City of
Richmond

Report to Development Permit Panel

File: DP 21-940028

Re: **Application by The Panatch Group for a Development Permit at 10140, 10160,
10180 No.1 Road and 4051 Cavendish Drive**

DRAWING TITLE -
SITE LAYOUT

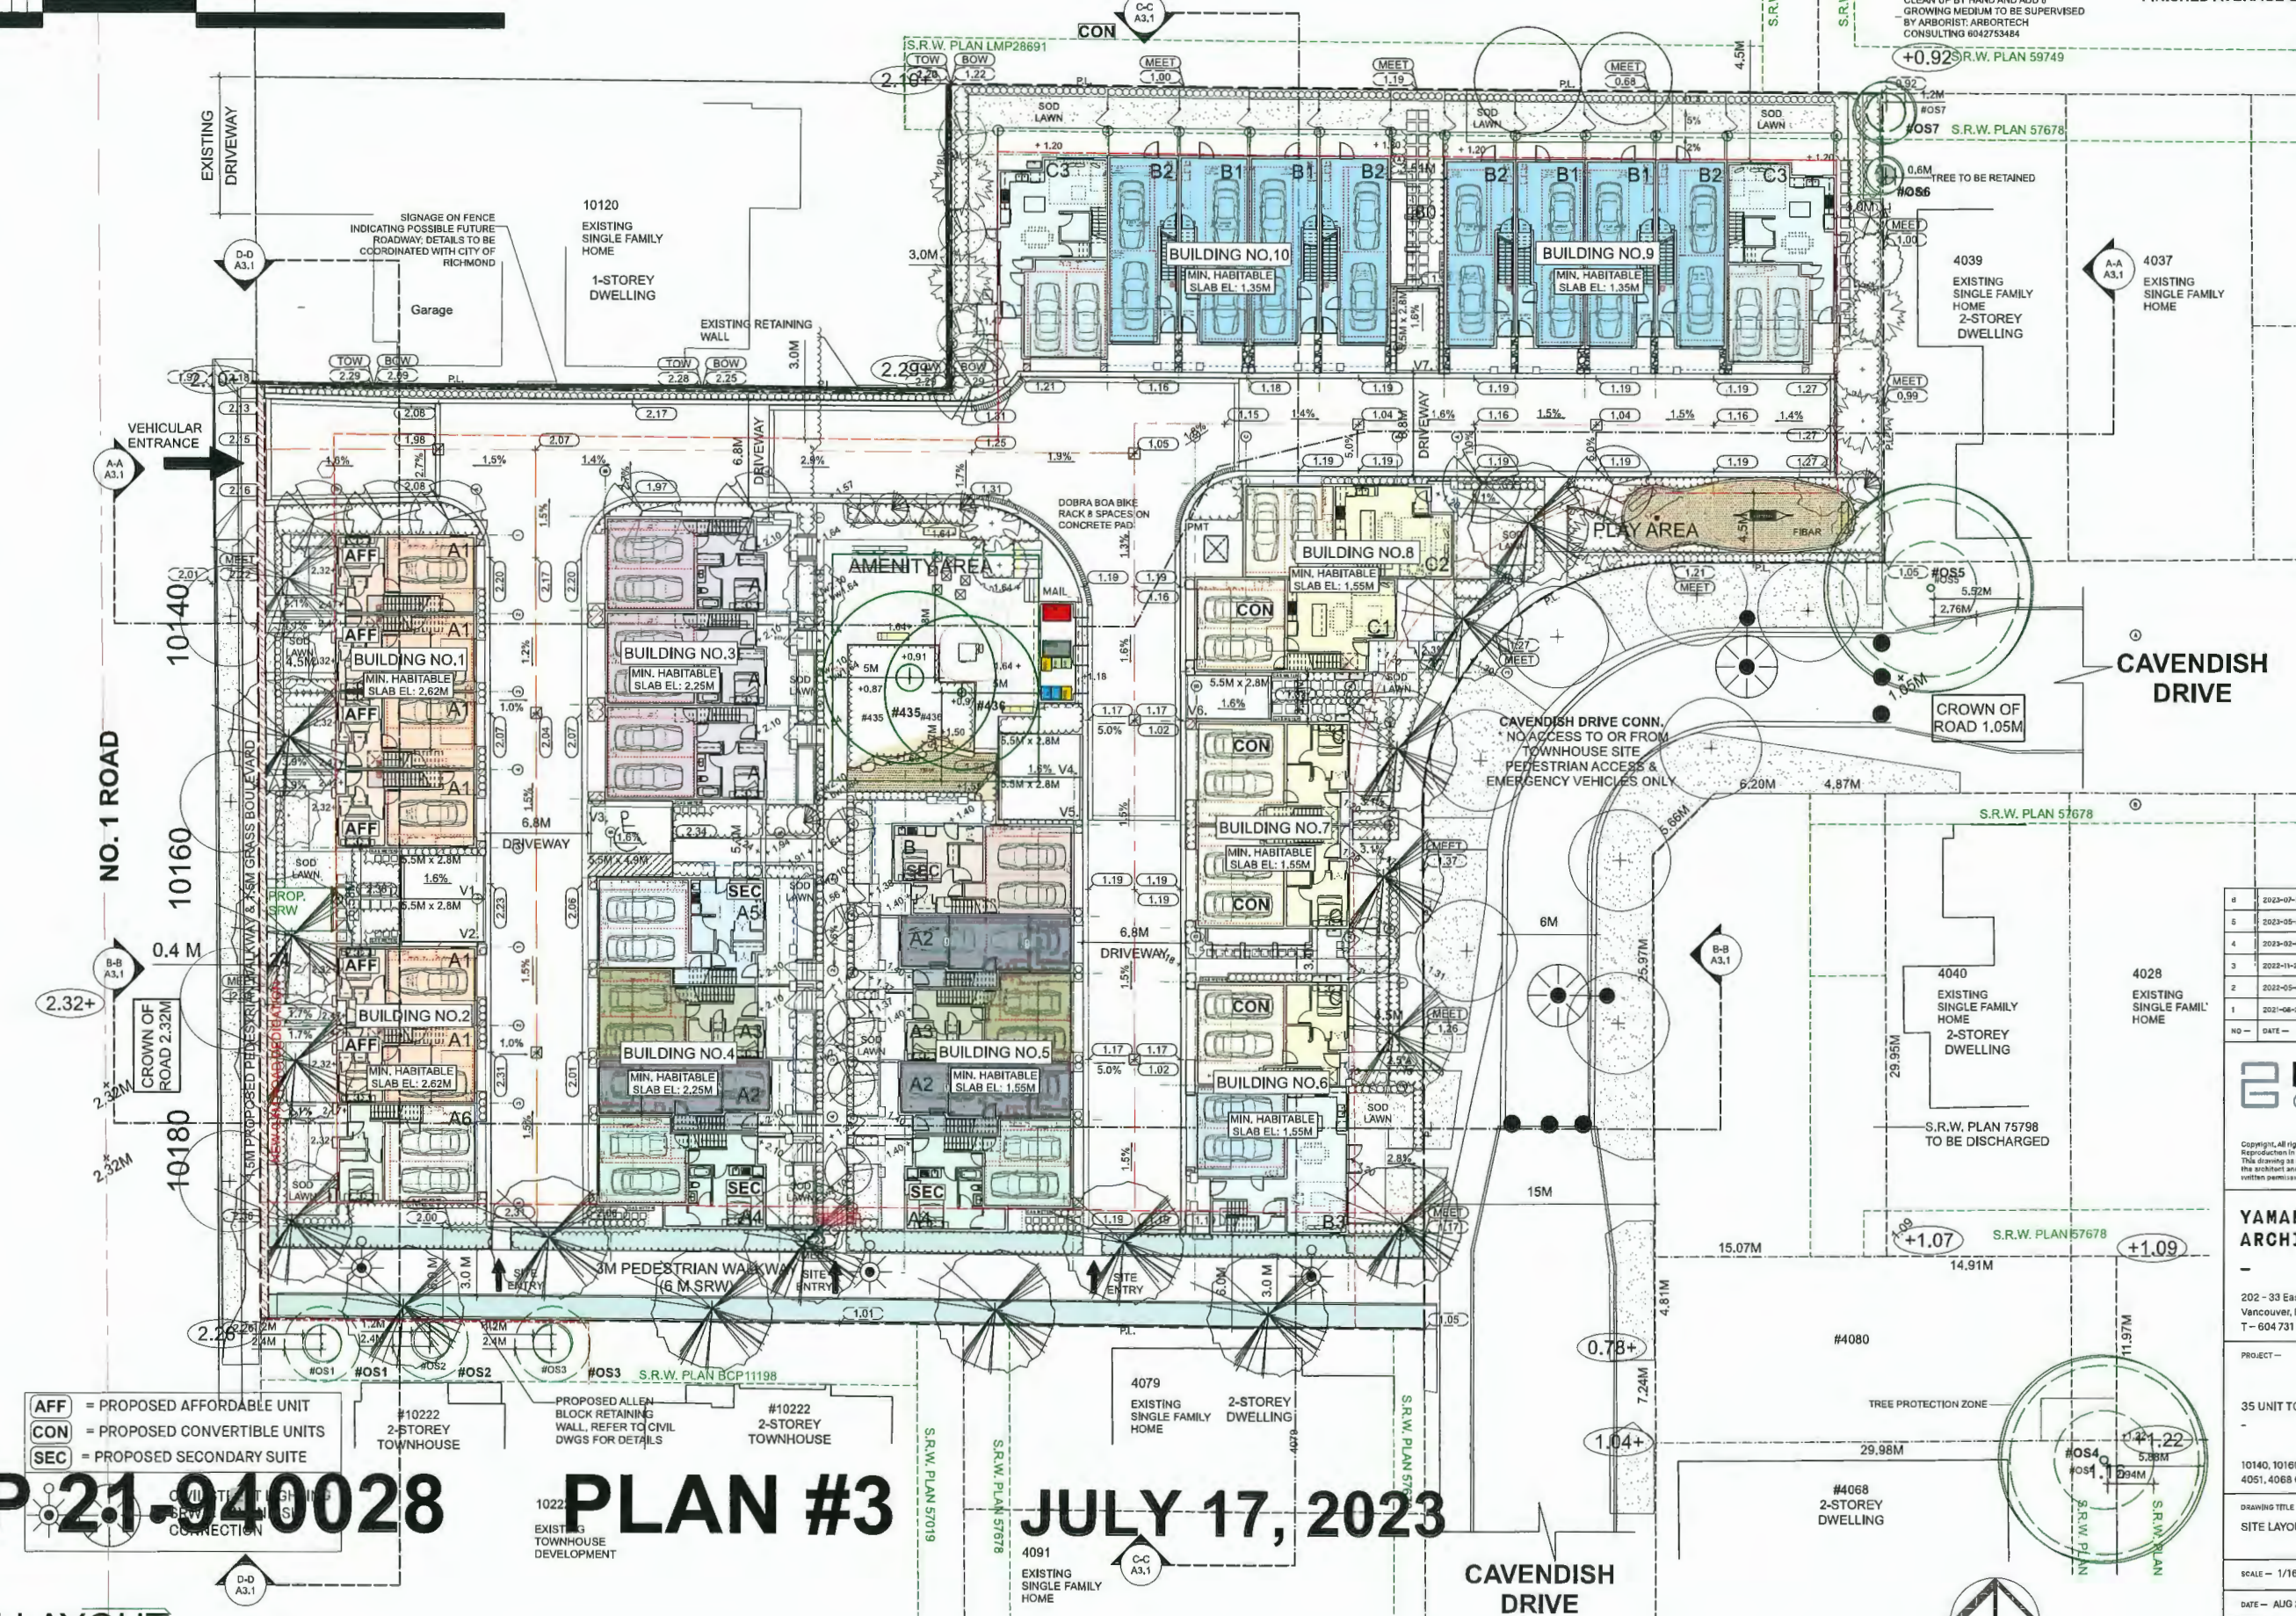
- the space for the bike rack in the central common outdoor amenity area appears tight on the plan; and

We have updated the site layout on sheet A1.0 and the landscape sheet L1 to show to bike stall locations within the central amenity area. Each bike stall location has been increased in size to provide better circulation to and from the bike racks. 7 bike stalls have been provided.

Noted. This has been adjusted to provide easier access. Dimensions shown on plan, refer to sheet L1.

UNIT EXTERIOR LIGHTING LAYOUT

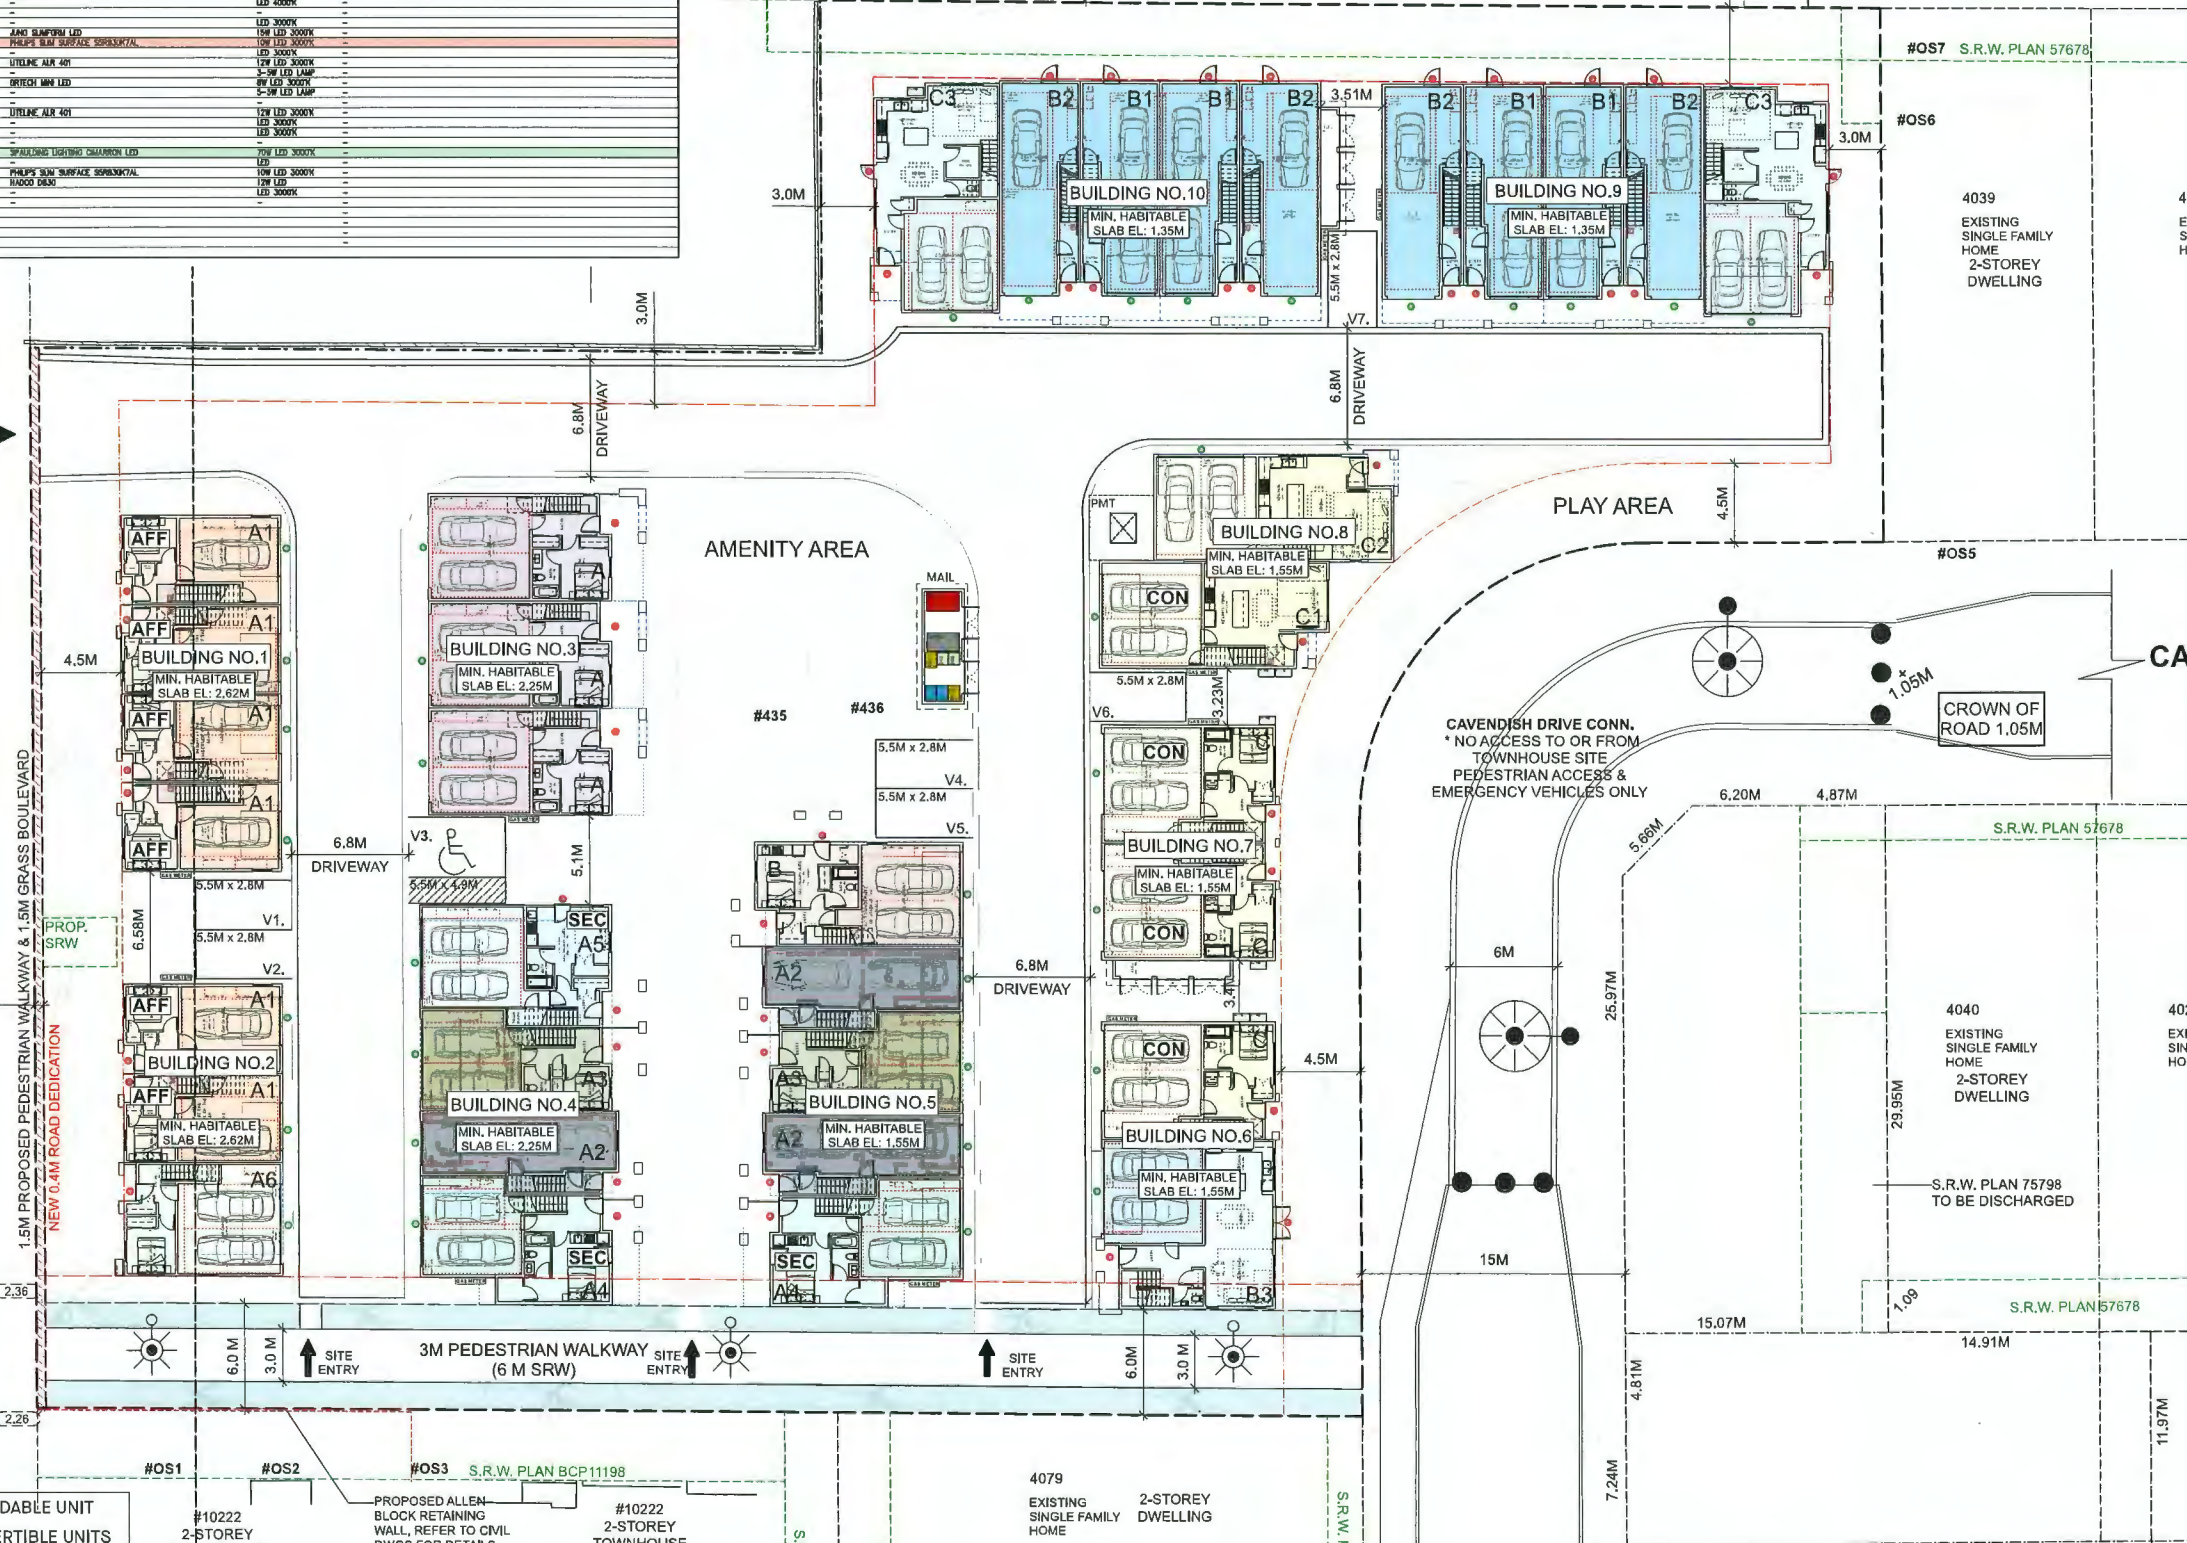
- unit entries in Buildings 3, 4 and 5 along the internal pedestrian walkway are recessed from the building face by as much as 8 feet due to the projecting decks above; consider reducing the distance of the unit entries from the edge of the projecting decks to provide more light access to the front doors and address CPTED concerns;

There will be sufficient lighting to mitigate CPTED concerns, and privacy and individuality of each entry will be reinforced by these 'entry porches' that are a strong character element of the project. Refer to the exterior unit lighting layout on sheet A5.8
